### HISTORIC PRESERVATION COMMISSION

SUBJECT: Historic Area Work Permit #1071643 - basement level alterations, grading, new door

The Montgomery County Historic Preservation Commission (HPC) has reviewed the attached application for a Historic Area Work Permit (HAWP). This application was **approved** at the June 12, 2024, HPC meeting with two conditions:

PROJECT NAME: 19811 DARNESTOWN RD BALCONY REPAIR

2ND FLOOR PLAN

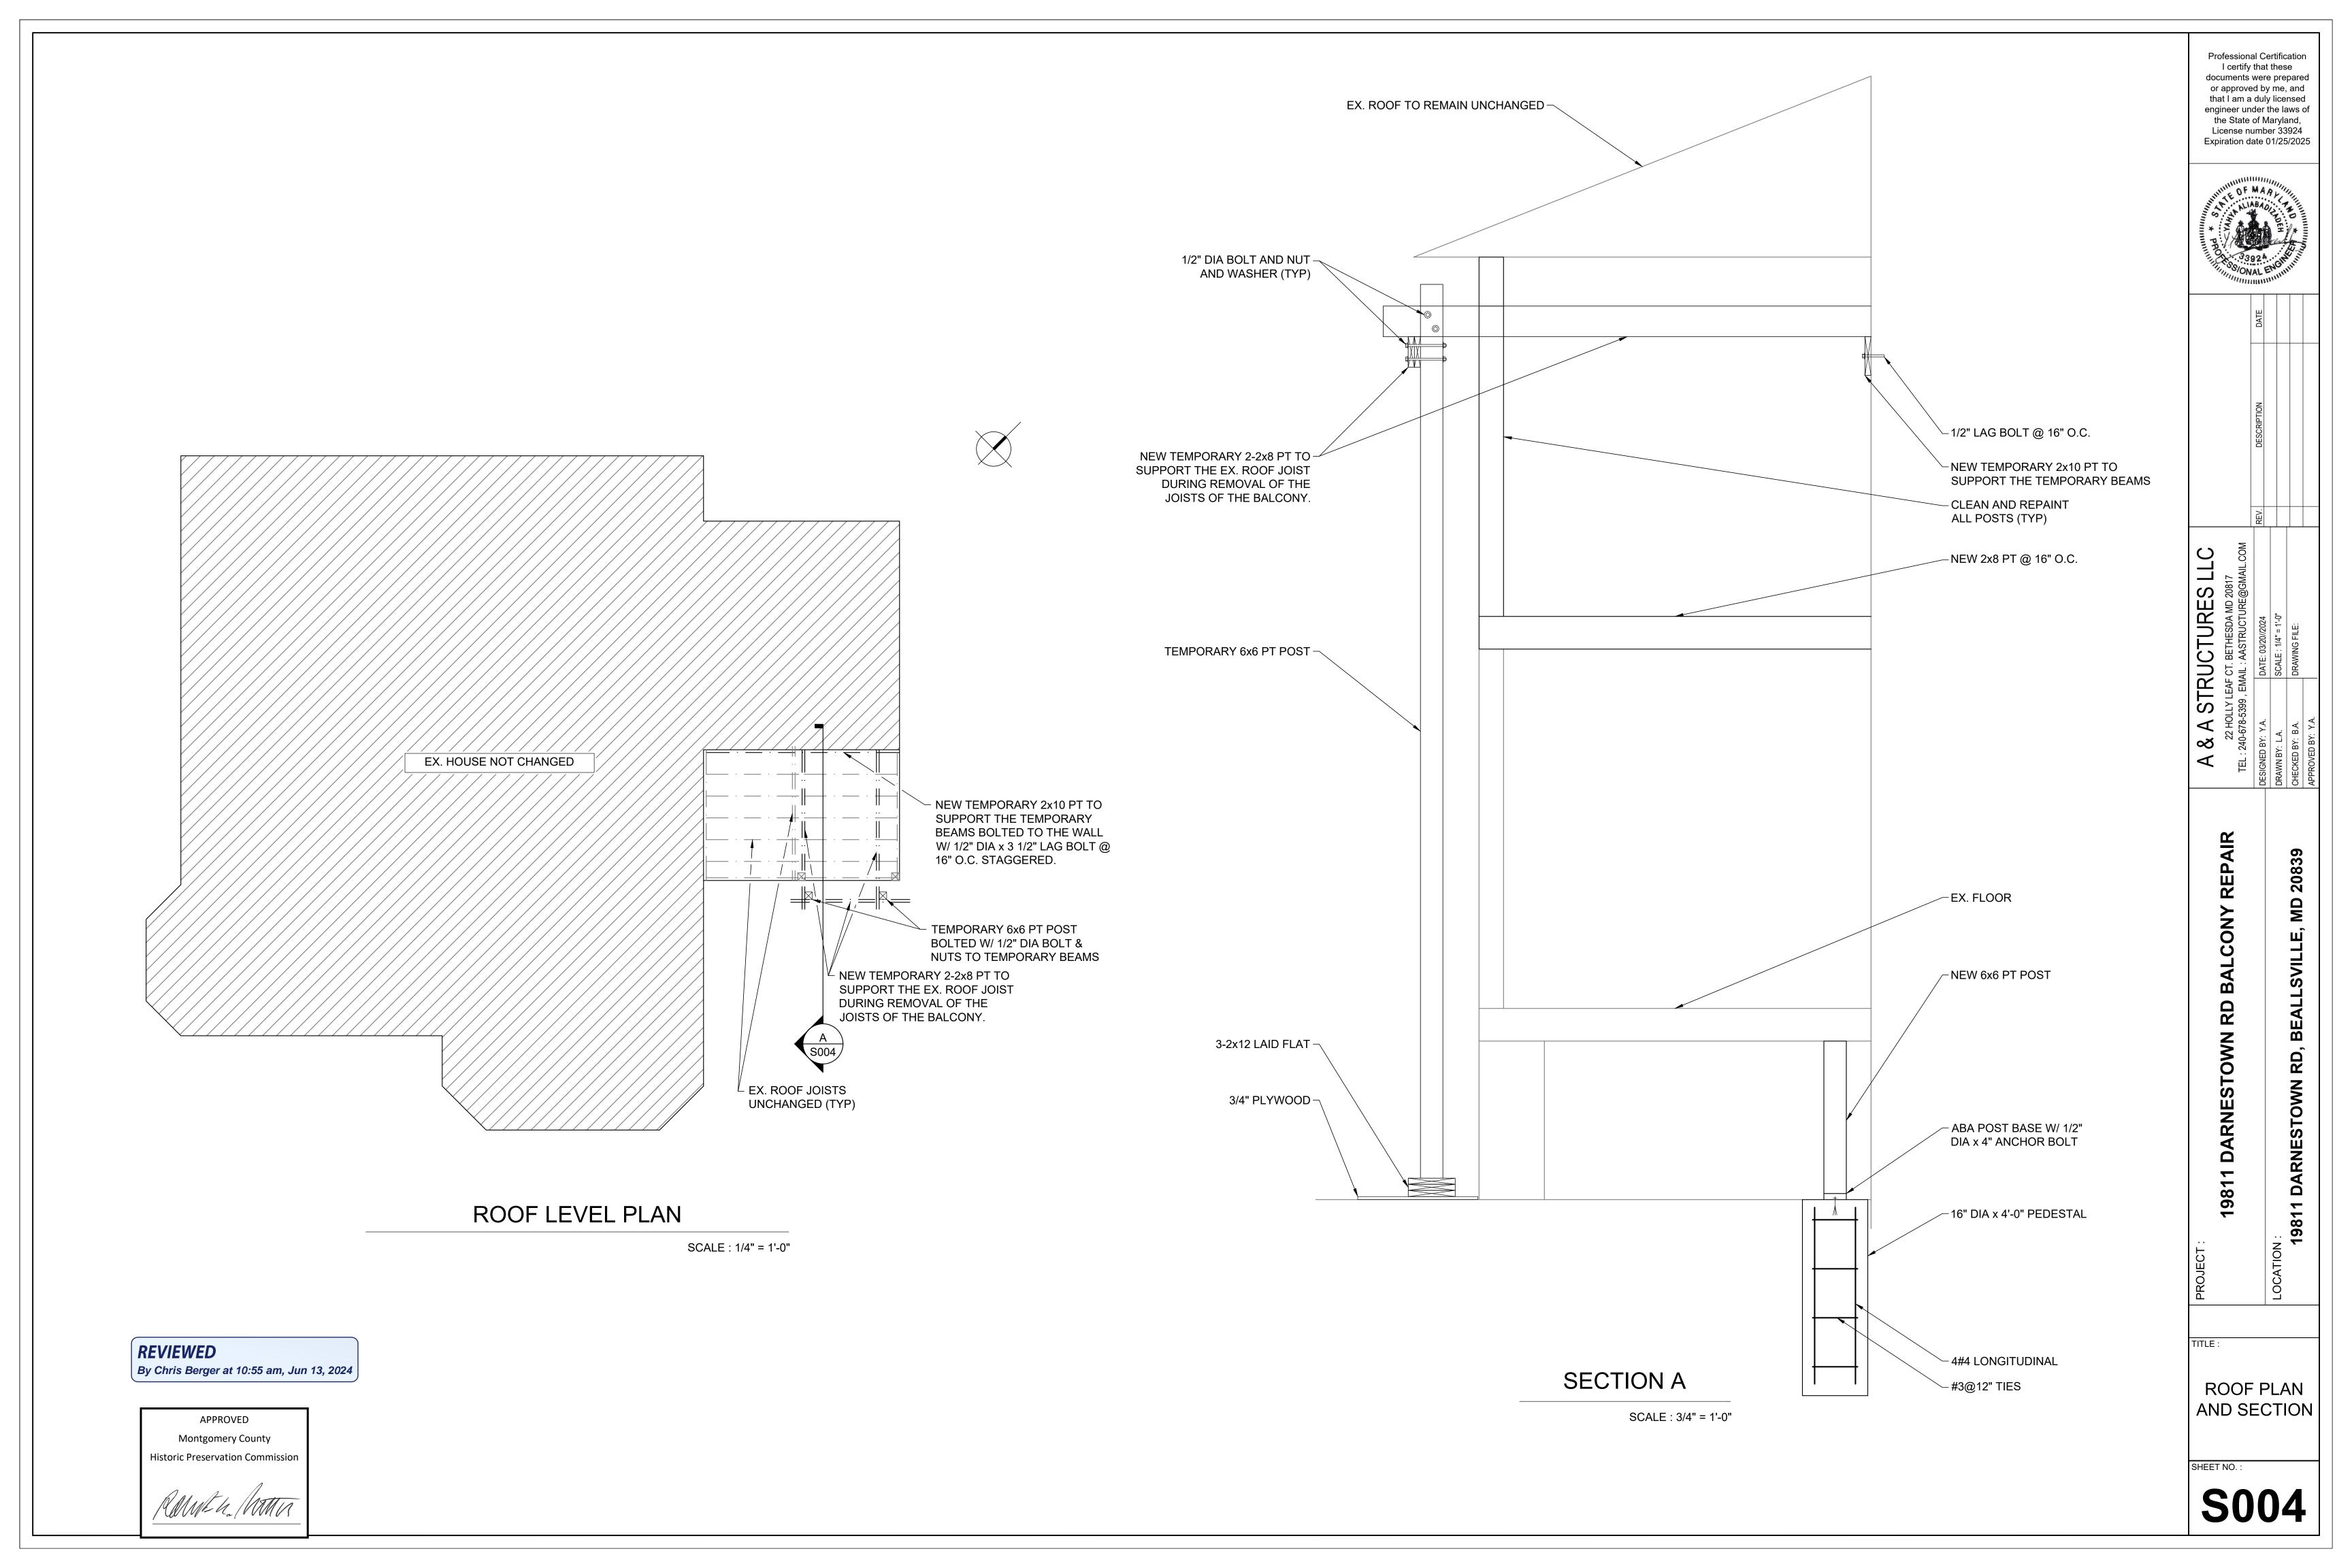
- 1. The beams to be installed under the second-floor porch must be painted to match the existing structural supports.
- 2. The wood basement access door must be salvaged and stored on site for potential future reuse.
